DOCKETED	
Docket Number:	25-OPT-02
Project Title:	Prairie Song Reliability Project
TN #:	269734
Document Title:	Response to Supplemental Data Requests Set 1
Description:	N/A
Filer:	Erin Phillips
Organization:	Dudek
Submitter Role:	Applicant Consultant
Submission Date:	4/30/2026 11:08:03 AM
Docketed Date:	4/30/2026

Supplemental Data Request Response No. 1

Prairie Song Reliability Project

Exhibit 1a. Previous Iteration of Landscape Plan (eastern boundary of North BESS Yard)

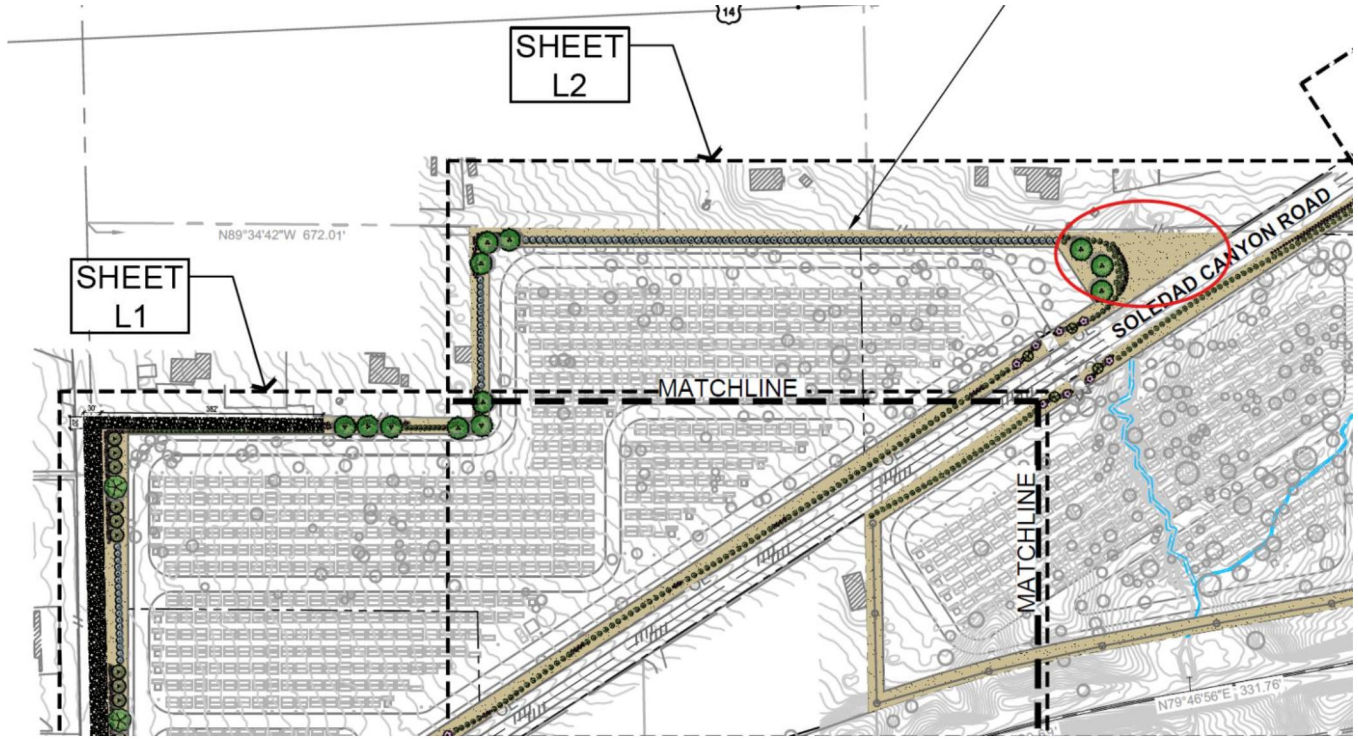
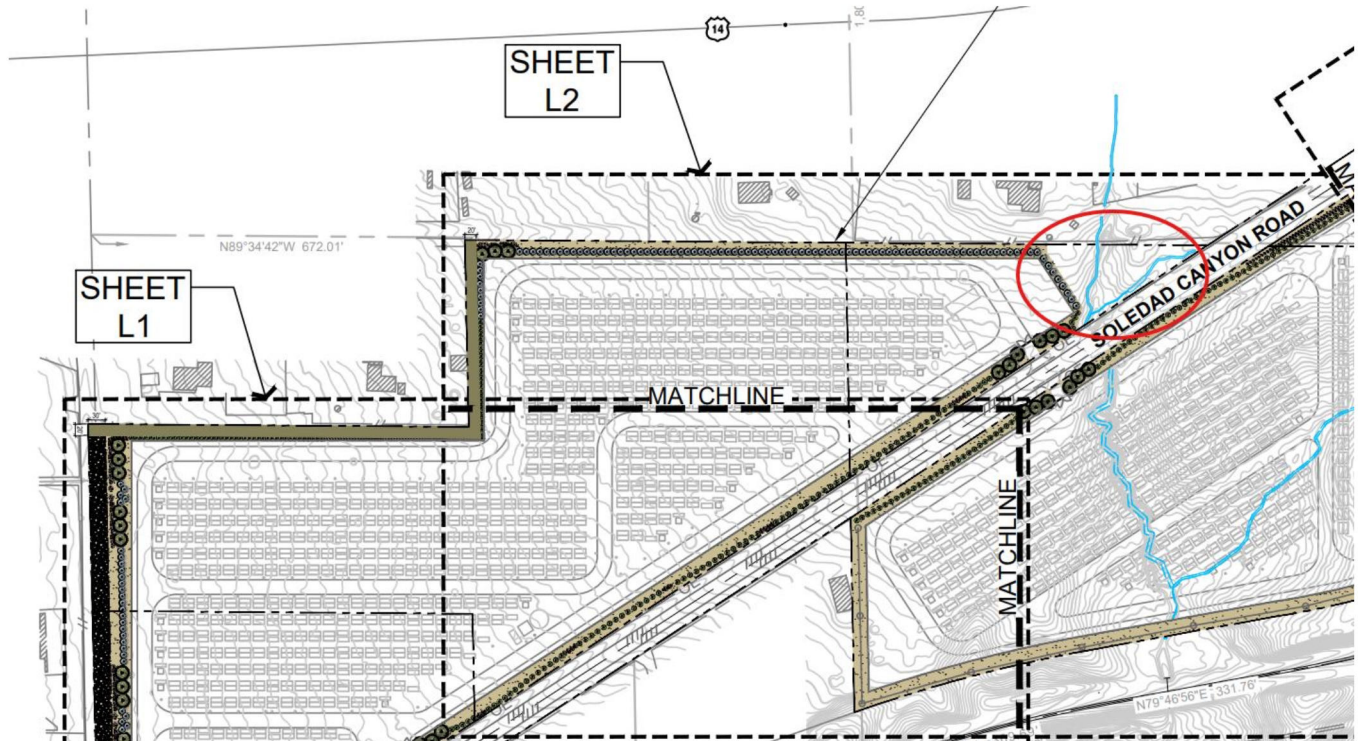
SDR 1 BIO-2. Please consider if the Landscape Plan should be updated or revised pursuant to SDR 1 BIO-1 and resubmit in redline and strikeout if necessary.

- Within the Eastern portion of the North BESS Yard (i.e., north of Soledad Canyon Road), landscaping has been reduced to avoid an aquatic feature. Exhibit 1 below shows the previous iteration of the landscaping plan in this area compared to the current/updated iteration.
